ORIGINATOR DRAWING TITLE								
University College London Hospitals NHS Foundation Trust					Scott Tallor	Proton Beam Therapy - Phase 4							
<u>.</u>		Name	Signature	Date	SCALE @ A1	BIM FILE NAME	VIE - Facade Details - Non Material Amendment Application						
,	Designed by	Designer	Cignatare	Date	1:10					, кррпоч			
ر. 0	Drawn by	Author			FIRST ISSUE DATE	PROPOSED STATUS	PROJECT ISSUER	AREA	LEVEL	TYPE	TRADE	SEQUENCE	REV
0	Checked	Checker			22/06/15	S2 - Issued for information	PAPRT STW	\/IE	SL	DET	A31	180060	ח
com	Approved	Approver			22/00/10		וטועודון	V I L	OL		A01	100000

Non-Material Amendment Application

Proposed Changes in relation to existing Planning Approval Ref: 2013/8192/P and clarifications of details as required under condition no. 3 with the exception of item 5 below.

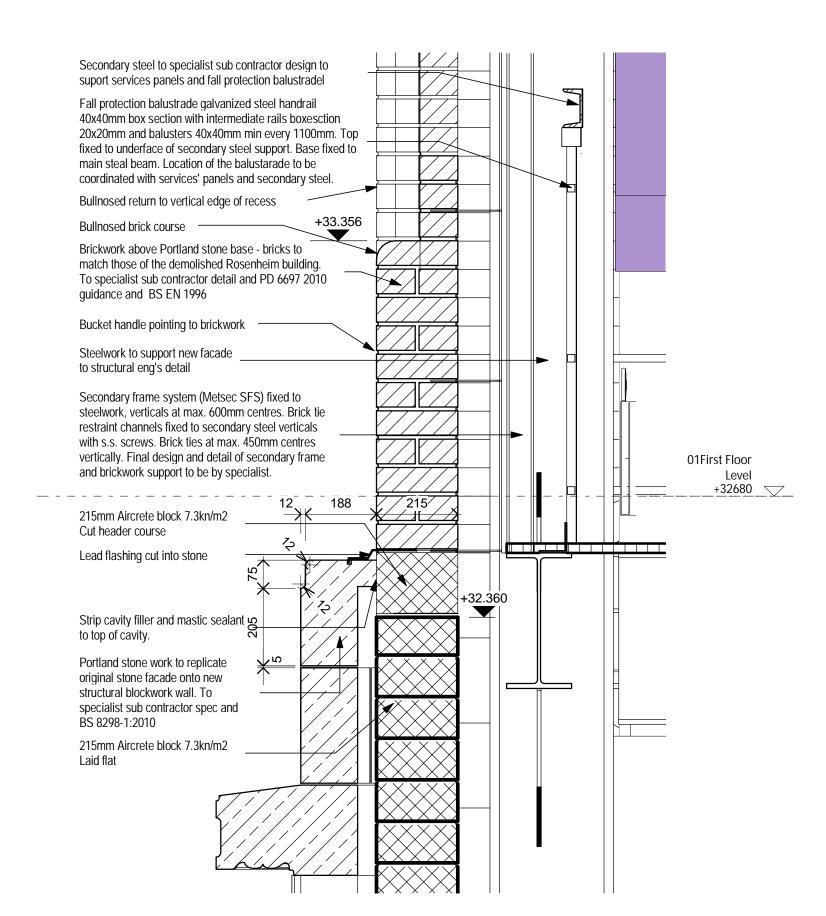
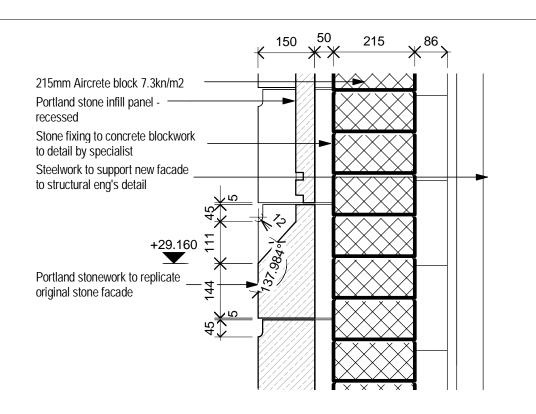
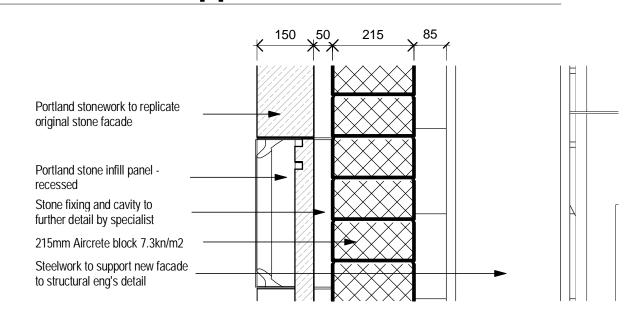
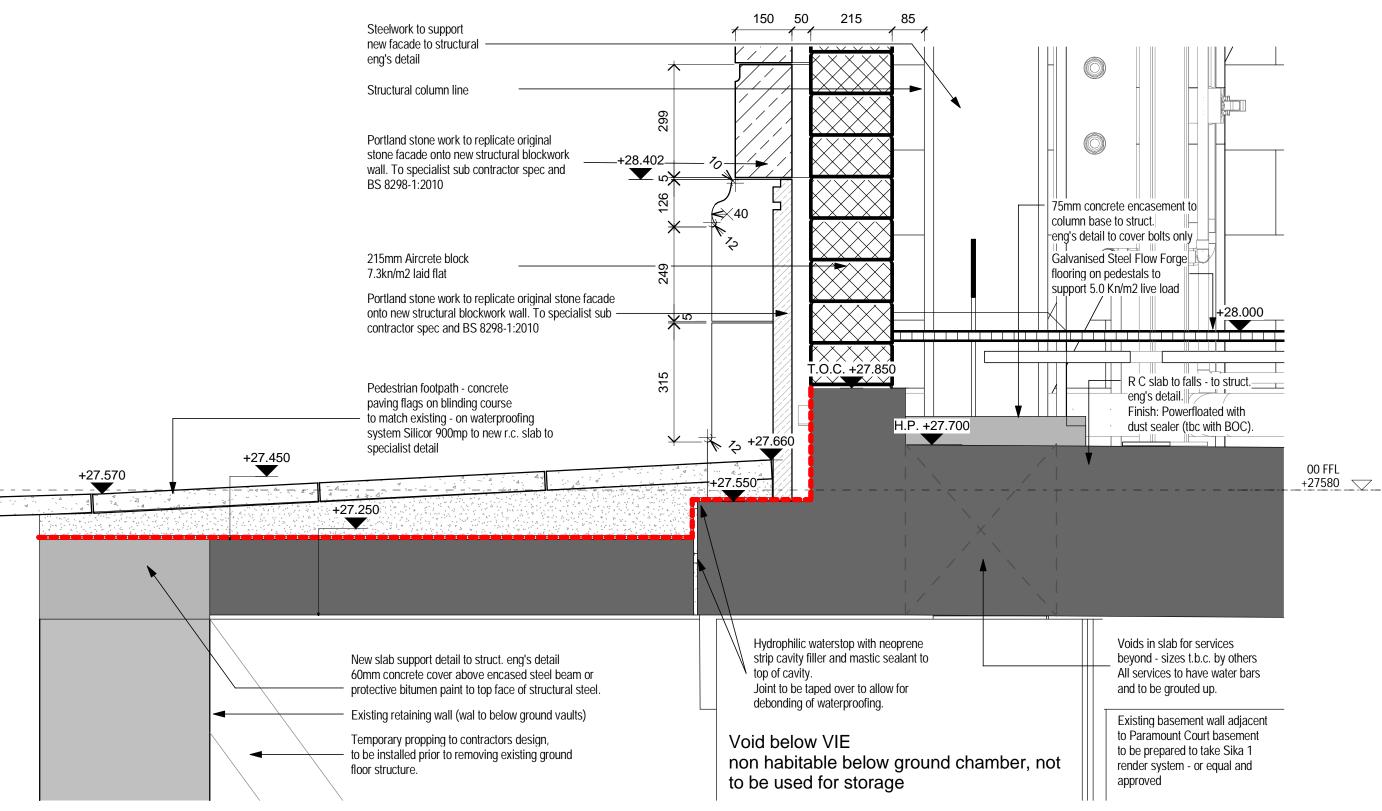
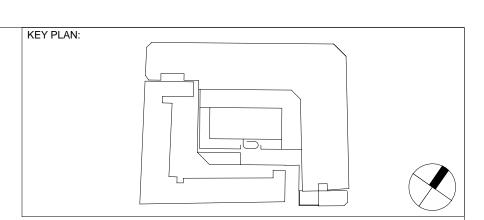
- 1. Base of the VIE enclosure to be reconstructed to replicate original external appearance of the Rosenheim building based on detailed surveys.
- 2. New brick enclosure will be constructed as a traditional solid brick construction.
- 3. Existing JB PUB gable wall to be externally clad with a new 100mm block work leaf up to VIE enclosure level. Above the VIE enclosure level the existing JB PUB gable wall will be externally clad with a new 100mm brickwork leaf to match JB PUB brickwork.
- 4. Undercroft level below proposed VIE ground floor slab will be a non habitable below ground chamber and will not be used for storage.
- 5. Final specification and details of the base (from ground to base of brickwork level) of the VIE enclosure will be subject to a further submission.
